**Carlisle ZBA  
Carlisle, Massachusetts  
October 4, 2016**

# **INDEPENDENT HYDROGEOLOGIC STUDY, 100 LONG RIDGE ROAD *PHASE 4 – 2016 REVISED PROPOSAL***

James H. Vernon, Ph.D., P.G.  
Nobis Engineering, Concord, NH

**FIGURE 2**  
BEDROCK CHARACTERISTICS  
PROPOSED SEPTIC DISPOSAL  
AREAS AND WELLS  
100 LONG RIDGE ROAD  
CARLISLE, MASSACHUSETTS

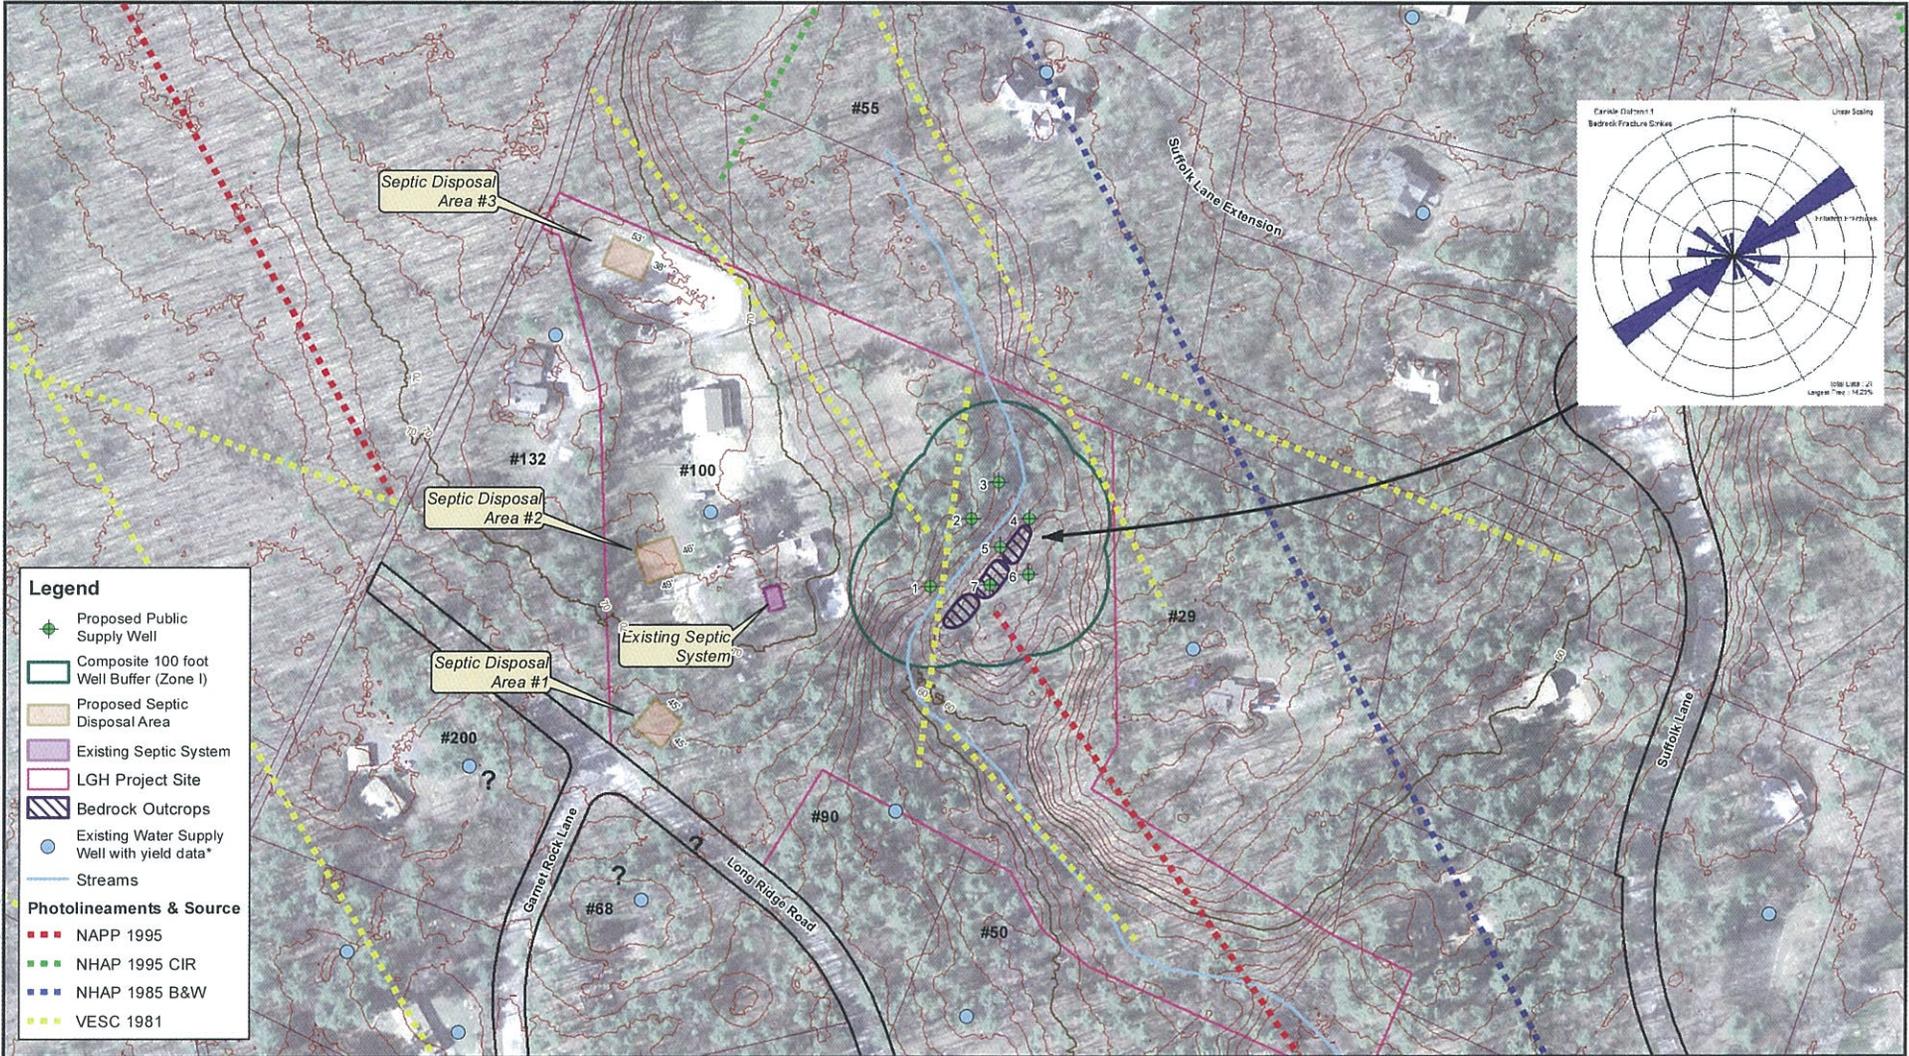
- Schist
- Outcrop fractures primarily NE; also NW; steep
- Photolineaments primarily NW
- NE and NW most likely groundwater flow directions in bedrock
- Degree of connection with overburden unknown.
- All water supply wells in bedrock

FIGURE 3	
AREAS OF IMPACT PROPOSED SEPTIC DISPOSAL AREAS AND WELLS 100 LONG RIDGE ROAD CARLISLE, MASSACHUSETTS	
PREPARED BY: JH	CHECKED BY: JV
PROJECT NO. 89220.00	DATE: SEPTEMBER 2016

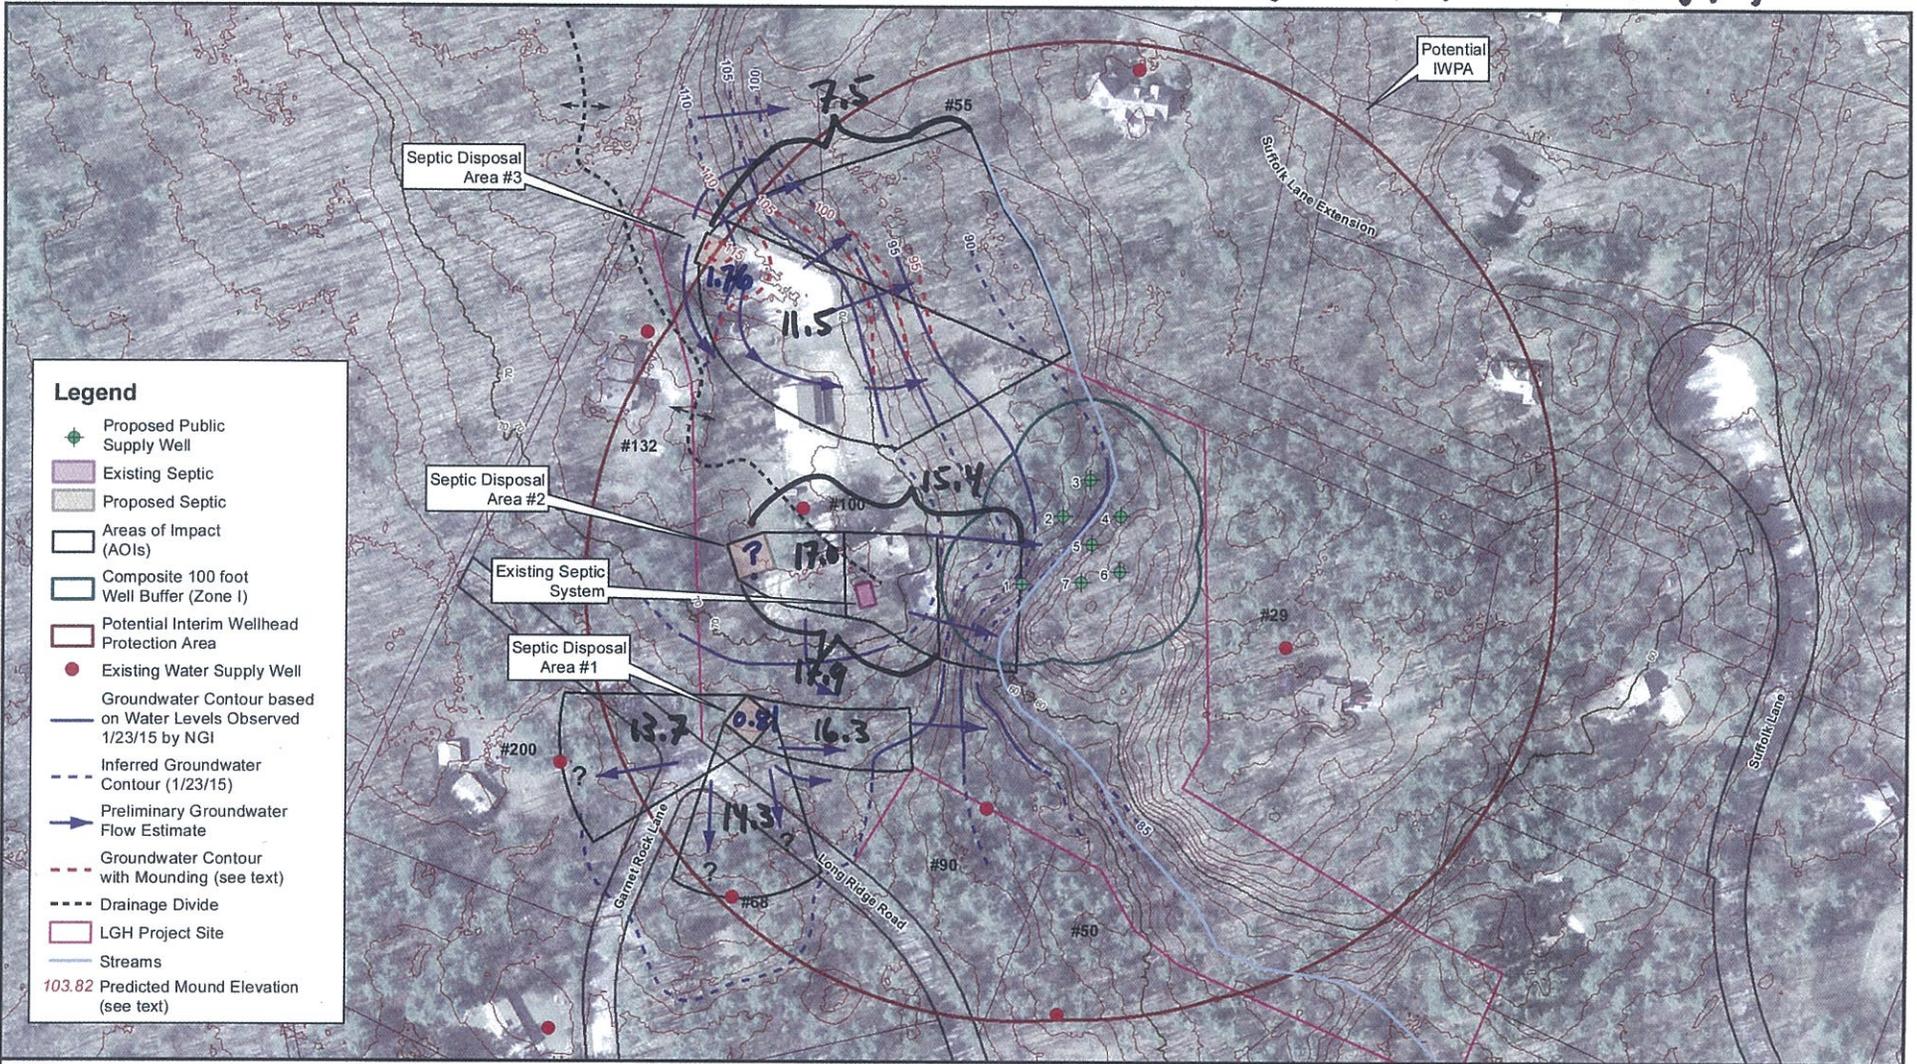
- Model assumptions
- Predicted mound heights
  - Septic Area 1: 0.81 ft after 180 days (5.8 ft depth to top)
  - Septic Area 2: 1.79? ft after 180 days (4? ft depth to top)
  - Septic Area 3: 1.76 ft after 180 days (3.3 ft depth to top)
  - *Note: results vary with assumptions*

- Use 2016 DEP Guidance
- Use applicant design parameter of 110 gpd per bedroom
- Regulatory, not “scientific” estimate
- Average for an area (AOI), not a point location
- Mass balance yearly dilution suggests nitrate load too great to be diluted below 10 mg/L for some AOIs
